Re: Turkey Point Units 3 and 4
Docket Nos. 50-250 and 50-251
License Amendment Request No. 207
Supplement 1 to Fuel Storage Criticality Analysis

LAR NO. 207
“FUEL STORAGE CRITICALITY ANALYSIS” -
SUPPLEMENT 1

Operating License and Technical Specifications Markups

FIGURE 5.5-4

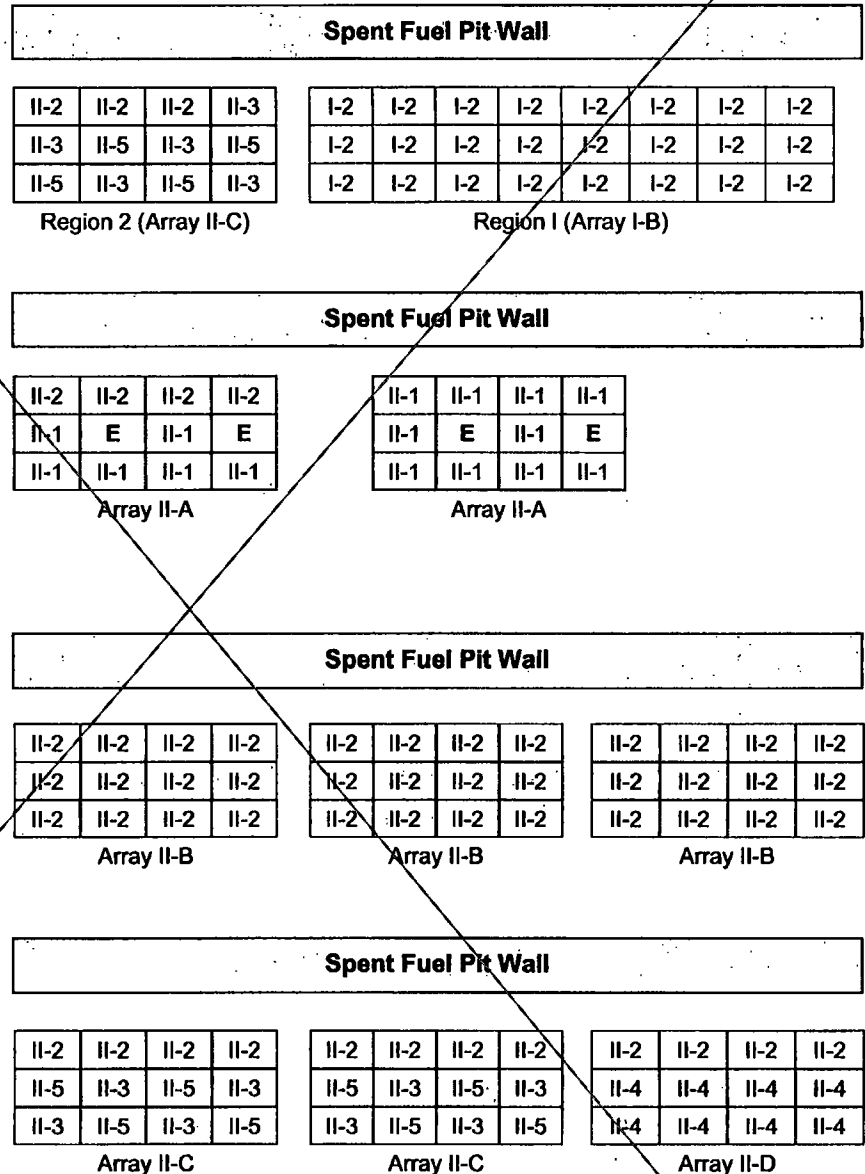
Figure 5.5-4 Figure deleted.

Figure 5.5-4 Figure deleted.

Basis for the Change: Technical Specification 5.5.1.3 is updated to reflect the new analysis results that revise the fuel categories and configurations. Technical Specifications 5.5.1.3.b.iv and 5.5.1.3.d are deleted as the new analysis does not contain specific requirements for cells adjacent to the spent fuel pit walls. Technical Specifications 5.5.1.3.c is updated to remove the statement with regards to configurations that are not part of the new analysis. A new Technical Specifications 5.5.1.3.d is added to specify the handling of fuel rod storage baskets or non-fuel hardware, as well as the acceptability of storing Metamic inserts or RCCAs in locations designated as empty cells. Note: A debris/trash storage basket may not be stored in a cell that is required to be empty by the criticality analysis (e.g. empty cells in configurations I-A and II-A). Technical Specifications Tables 5.5-1, 5.5-2 and 5.5-3, as well as Figures 5.5-1, 5.5-2 and 5.5-3 are replaced with the new analysis results that revise the fuel categories and configurations. Technical Specifications Table 5.5-4 is added to specify burnable absorber (IFBA) requirements for fuel category I-2. Technical Specifications Figure 5.5-4 is deleted as the new analysis does not contain specific requirements for cells adjacent to the spent fuel pit walls.
